Stormwater Management Plan

DRIP DISTRIBUTION PLAN SUBMITTAL REVIEW

SITE PLAN FOR MCKINLEY

S/L 6 STONE RIDGE DRIVE (STONE CREEK SUB)
AND LAKE COUNTY STATE OF OHIO

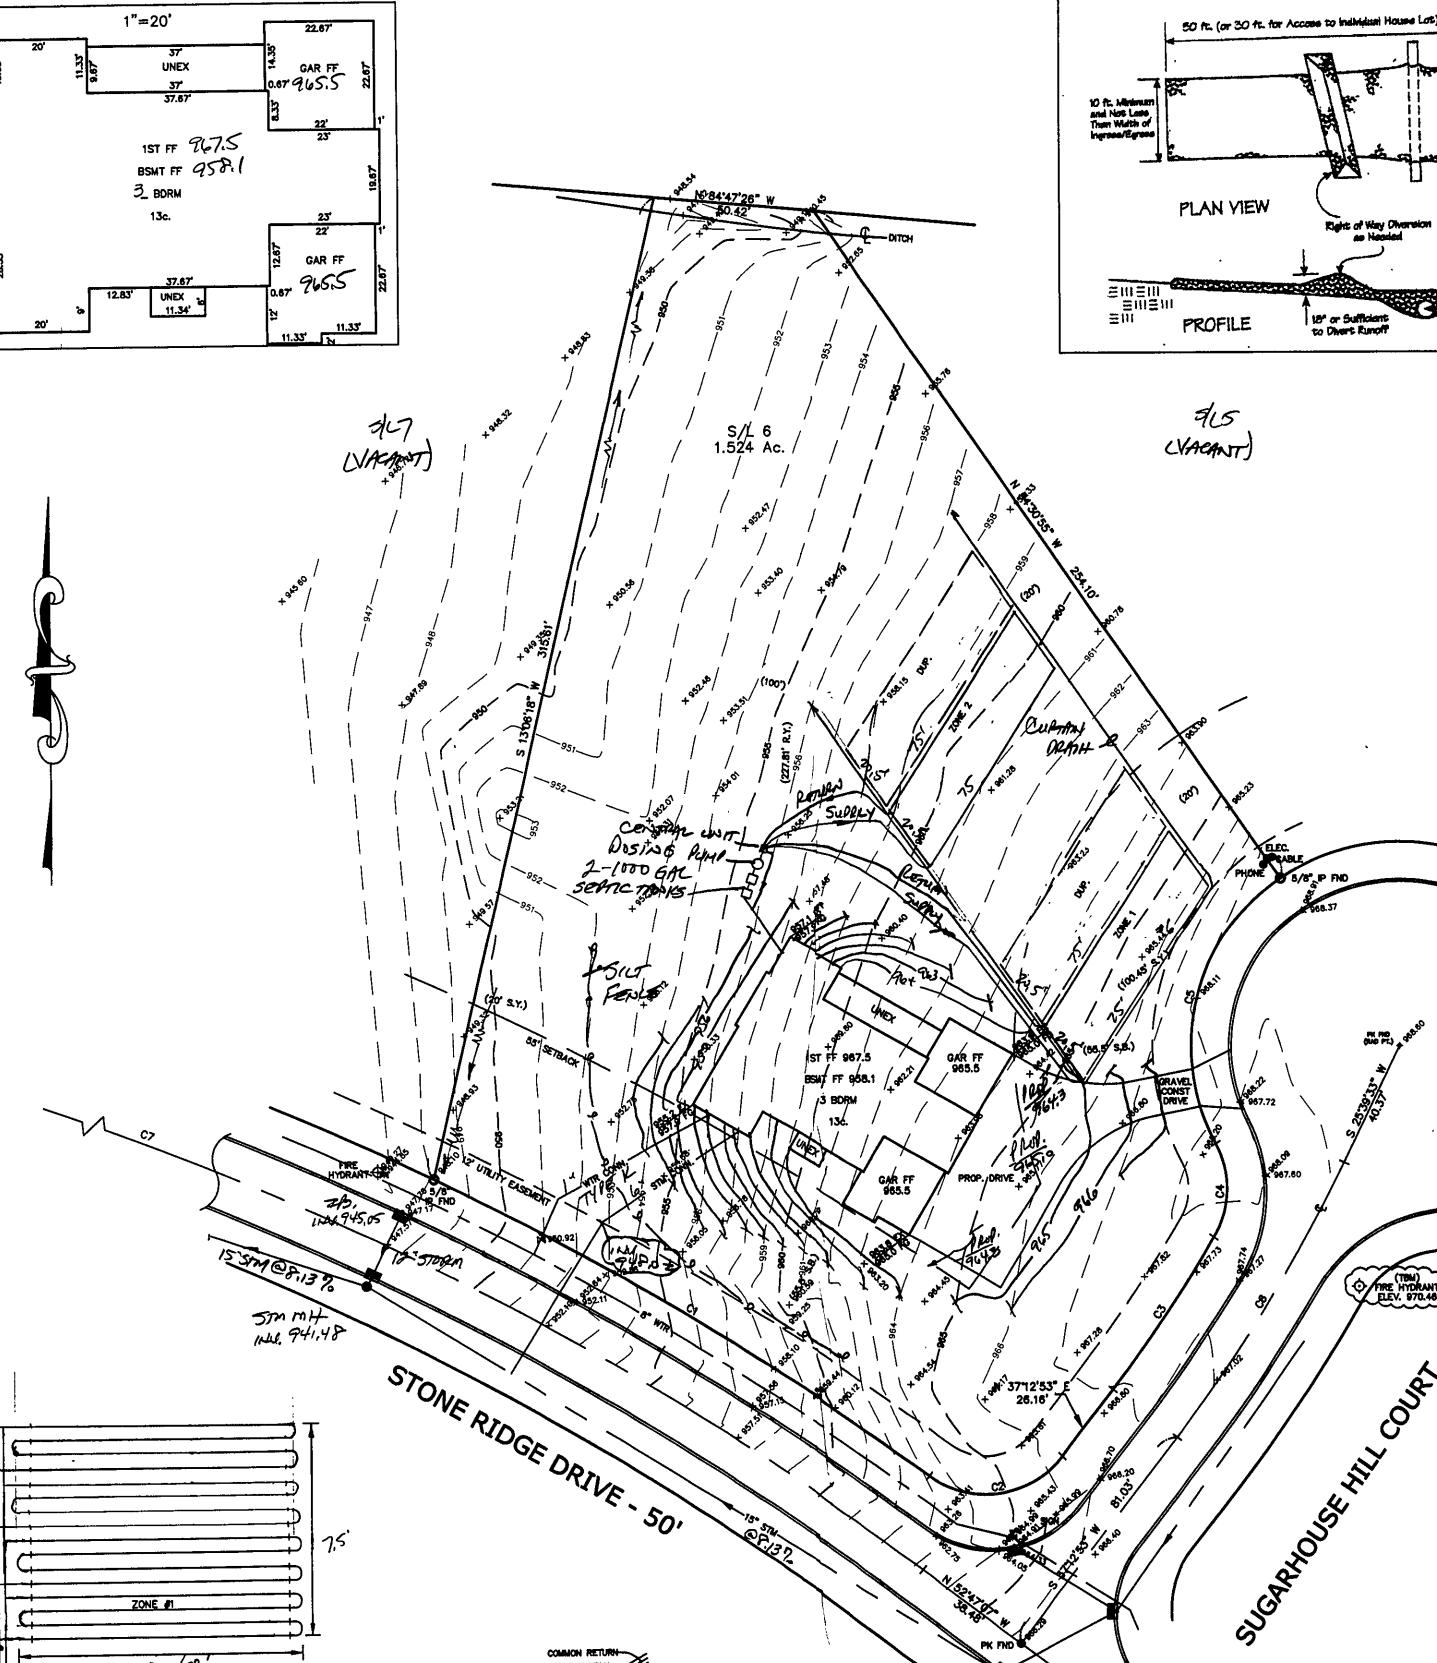
Approved as shown and/or noted

Drip distribution area has been field venified and protected with marking tape

Plans submitted to LCGHD and meet design criteria

Hydraulic calculations verified and accurate
